UNITED STATES OF AMERICA
NUCLEAR REGULATORY COMMISSION

Docket No. 63-001

(High Level Waste Repository)

THE NUCLEAR ENERGY INSTITUTE'S PETITION TO INTERVENE

Figure 1. Comparison between the disposal of a 21-PWR waste package with a TAD disposal overpack and DPC disposal, assuming 100 percent of the waste packages are DPCs. (EPRI, 2008a, Figure 19, page 6-2).

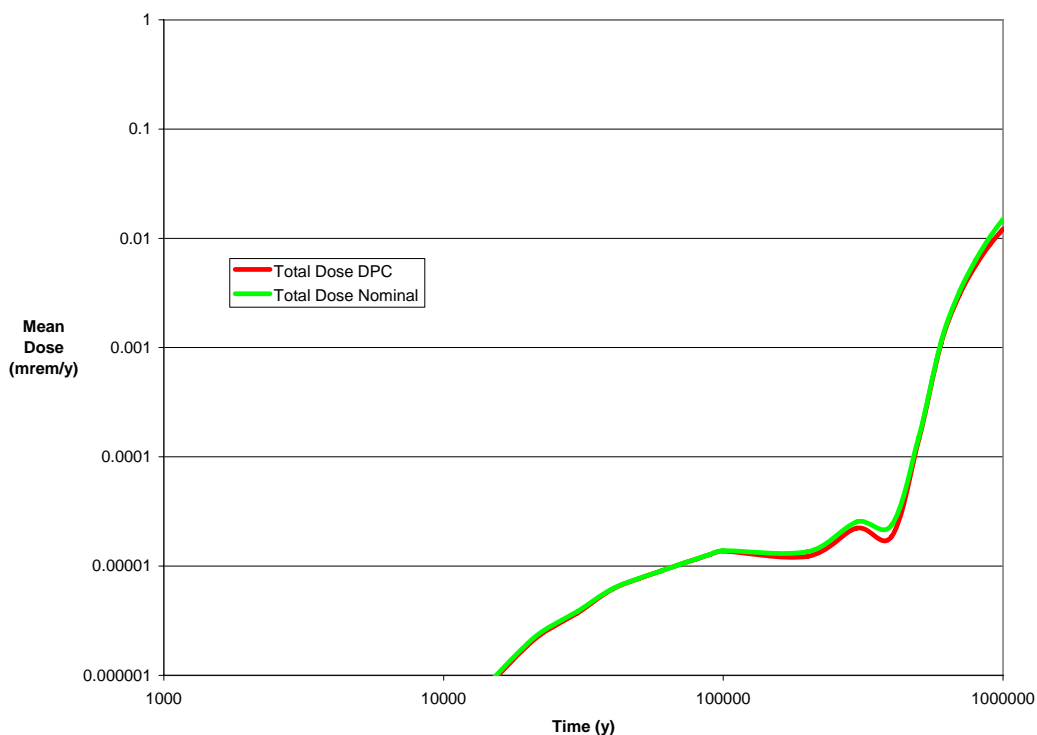
70. (MK) For TSPA analyses, EPRI concluded that only very minor differences exist between DPC disposal and TAD disposal for a variety of scenarios, assumptions, and sensitivity analyses. EPRI 2008 at p. 8-1. The comparison between TAD disposal and DPC disposal for the nominal scenario is shown in Figure 1 below. Evaluations were conducted for the nominal scenario, for the credible alternative scenarios of volcanism and seismic disruption, and for a scenario that has been screened from TSPA because of low probability: the criticality scenario. In all analyses, both DPC disposal and TAD disposal demonstrated acceptable post-closure performance.

Figure 1: Decision Tree for the Function of the Drip Shield to Prevent Seepage Drips from Contacting the Waste Package.

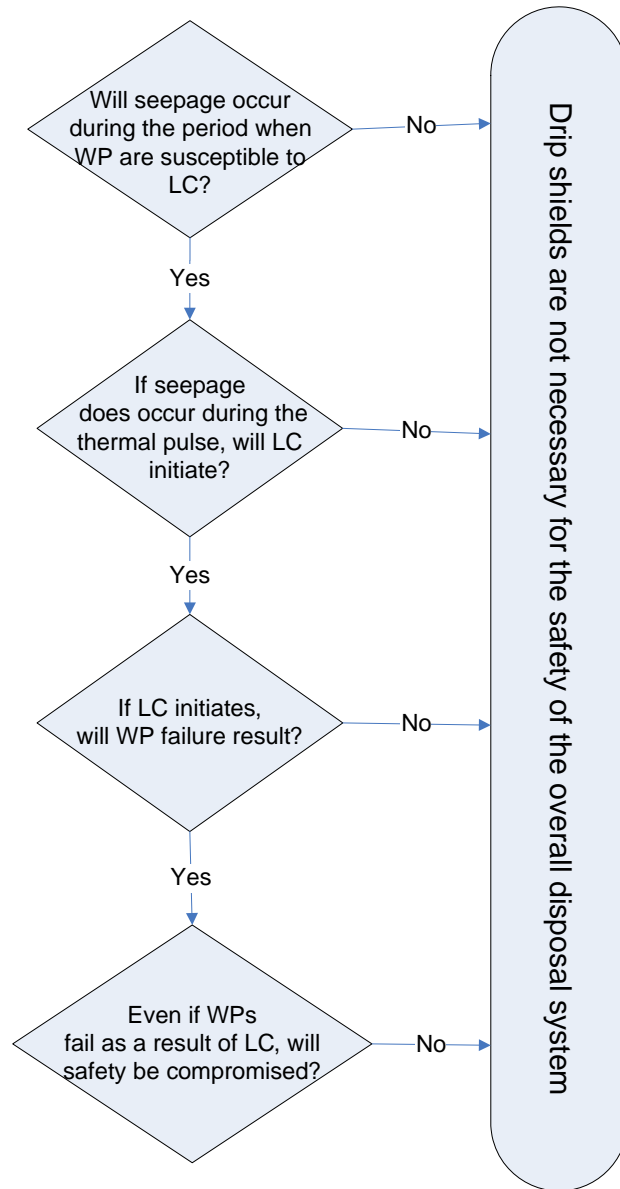
32. (FK) Figure 1 below shows a decision tree illustrating the important factors associated with the function of the drip shield to protect the waste packages from seepage drips, which, under DOE's conservative analyses, could lead to localized corrosion of and eventually failure of some waste packages. As shown in Figure 1 below, for the drip shield to be a necessary barrier, each of the questions in the decision tree must be answered in the affirmative. If any one of these questions is answered negatively then the failure mechanisms postulated by DOE are not credible and, hence, the drip shield is not necessary. (The abbreviations "LC" and "WP" in Figure 1 mean "localized corrosion" and "waste package" respectively.)

33. (FK) Localized corrosion is only possible during the period of elevated waste package temperature (greater than 100°C) and then only if seepage waters contact the surface of the waste package, a process that the drip shields were designed to prevent. The first necessary process is the seepage of water into the drift during the period of time that the temperature of the waste package is hot enough (i.e., during the initial thermal pulse) to support localized corrosion. Although seepage is considered possible, the amount of seepage water is considered to be significantly less than that assumed by DOE, as outlined below. The second necessary condition is that localized corrosion initiate. It is accepted here that the initiation of localized corrosion could occur if the composition of the seepage water is aggressive (i.e., a high chloride

concentration and a low concentration of inhibitive ions, such as nitrate, sulfate, and bicarbonate). Third, if localized corrosion initiates, it is necessary that it penetrate the waste package if it is to affect the safety of the system. In this regard, it is my opinion that the DOE analysis is overly conservative and ignores processes that will lead to the cessation of this form of corrosion. Fourth, even if one assumes that waste package failure will occur by localized corrosion, the safety of the overall multi-barrier system will not be compromised. Here, again, I believe that the DOE analysis is overly conservative.

Figure 2: Decision Tree for the Function of the Drip Shield to Prevent Rockfall from Causing Structural Failure of the Waste Package

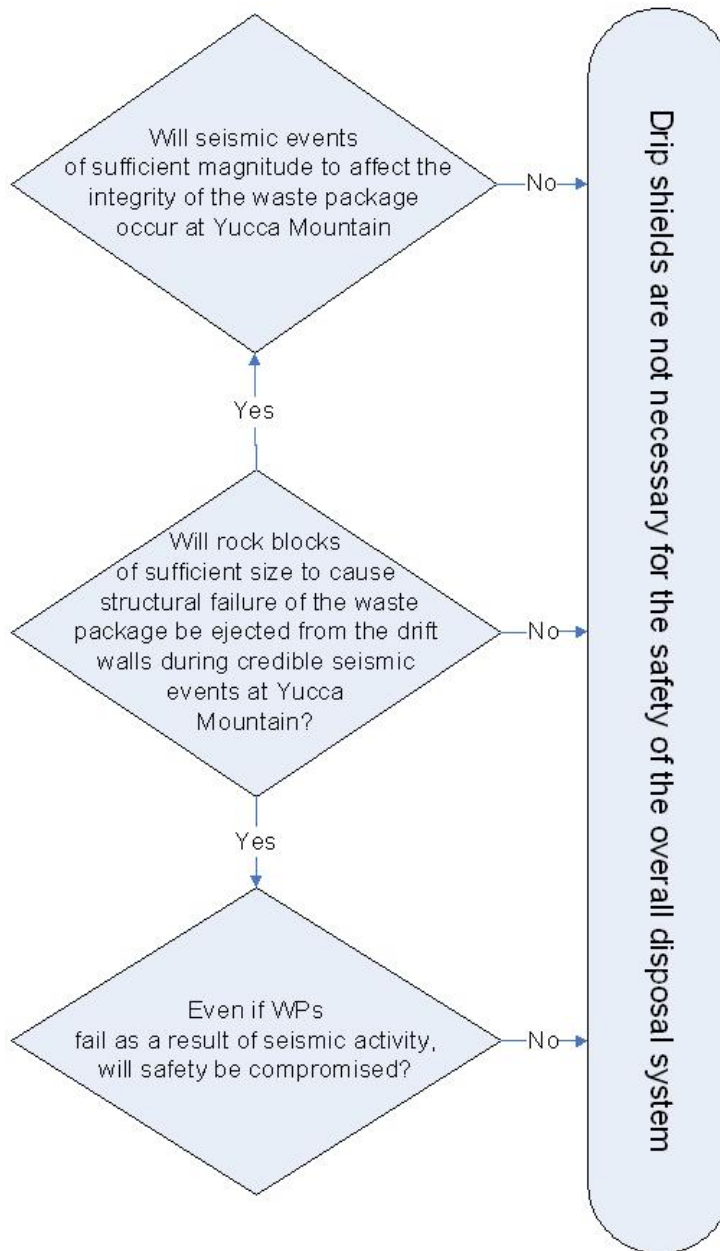
47. (FK) The decision tree in Figure 2 outlines the necessary processes that must occur for rockfall to cause structural failure of the waste package. The first requirement is that seismic events of sufficient magnitude must occur at Yucca Mountain. DOE’s conservative assessment of the magnitude of possible seismic events at Yucca Mountain results in an over-estimate of the credible size of rocks that could be ejected from the drift walls. Second, for rocks of credible size, the kinetic energy of these rocks must be sufficient to puncture or otherwise structurally fail the waste package. Finally, even if a few waste packages do fail because of

impact from large rocks, the safety of the entire repository system may not be compromised if the number of affected waste packages is small or if the remaining natural and engineered barriers provide sufficient containment. In addition to a conservative assessment of structural failure of the waste package by ejected rocks, DOE's analysis of structural failure by seismically-induced vibratory ground motion is also conservative, as discussed below.

Figure 3: Decision Tree for the Function of the Drip Shield to Prevent Rockfall from Damaging the Waste Package Leading to Stress Corrosion Cracking Failures

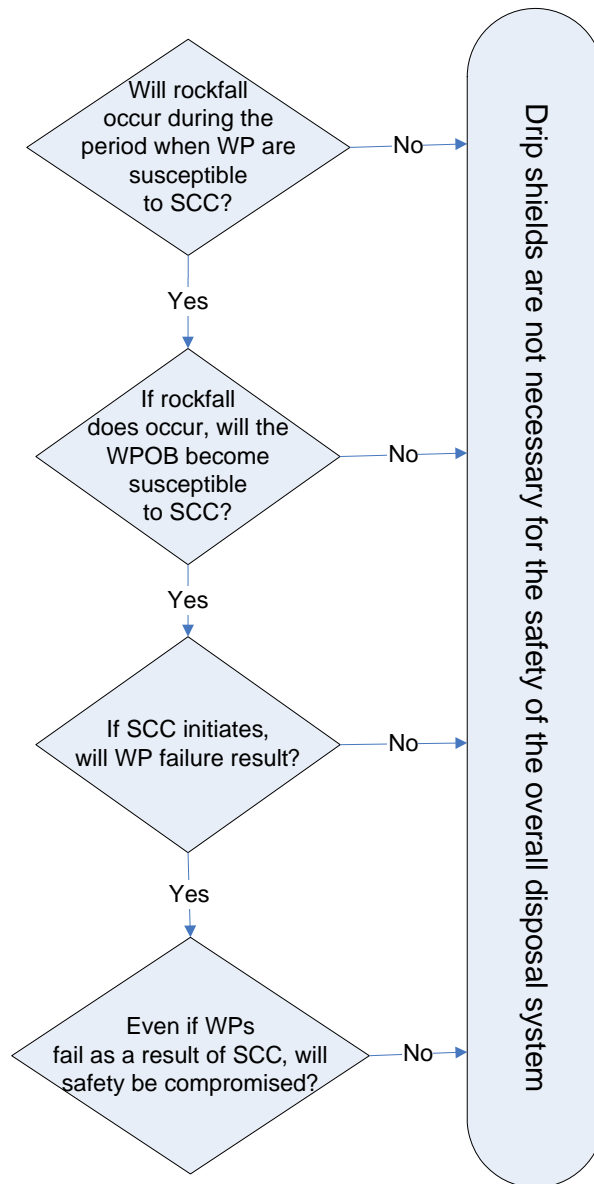
55. (FK) The decision tree in Figure 3 outlines the necessary processes that must occur for rockfall-induced waste package failure by SCC to be important to waste isolation. The first prerequisite for rockfall-induced SCC is that rocks either impact or accumulate on the waste package surface as a result of seismic activity. DOE's conservative assessment of the magnitude of possible seismic events at Yucca Mountain results in an over-estimate of the amount of rockfall in the drifts. Second, initiation of SCC requires that three criteria be met: (1) the tensile residual stress imparted by the rock impacts or accumulated rock pile exceed a threshold value; (2) the seepage water composition must be supportive; and (3) the electrochemical corrosion potential must exceed a threshold value. DOE conservatively ignores the latter two in its analysis. Third, if SCC initiates, the crack must propagate entirely through the wall for waste package failure to occur. It is conservatively assumed here that, once initiated, an SCC crack will propagate to failure. Fourth, even if a few waste packages do fail by SCC, the safety of the entire repository system may not be compromised if the number of affected waste packages is small or if the remaining natural and engineered barriers provide sufficient containment.

Figure 4. Comparison of EPRI's Base Case (a) and No Drip Shield (b) TSPA Results

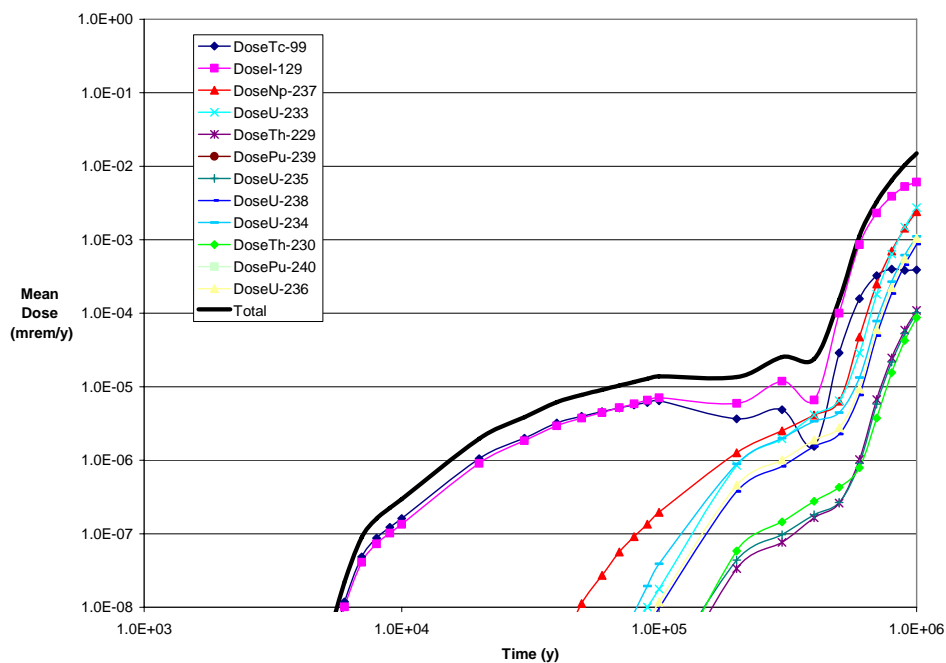
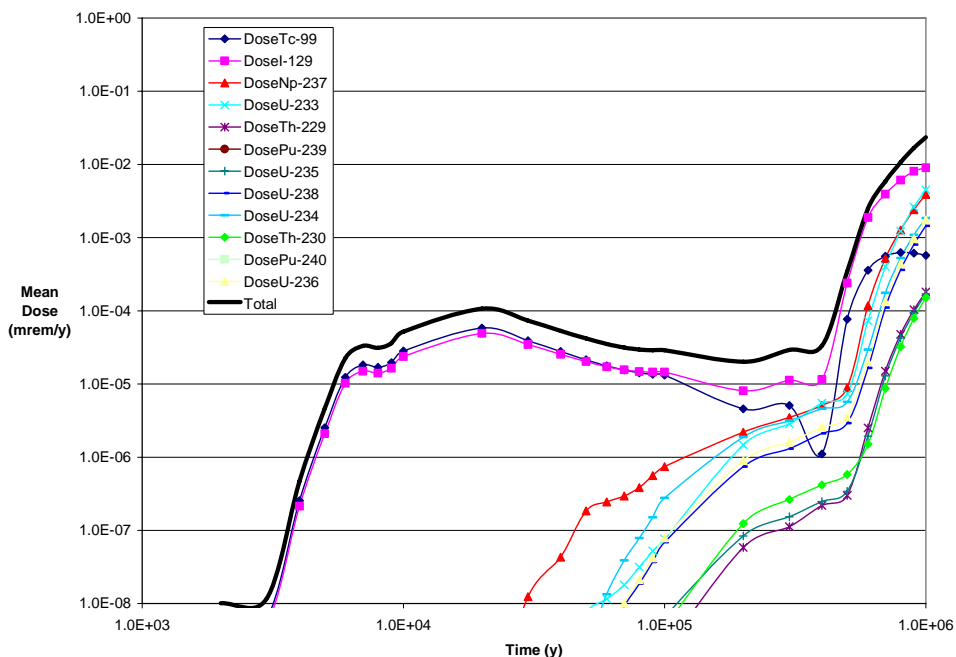
71. (MA) The results of a sensitivity analysis in which the drip shields are assumed to be absent is shown in Figure 4(b). As EPRI noted (EPRI 2008, p. 6-17) there is a moderate increase in doses at early times associated with the waste package that is assumed to be initially failed due to manufacturing defects, but the change in peak dose without the presence of the drip shields is negligible.
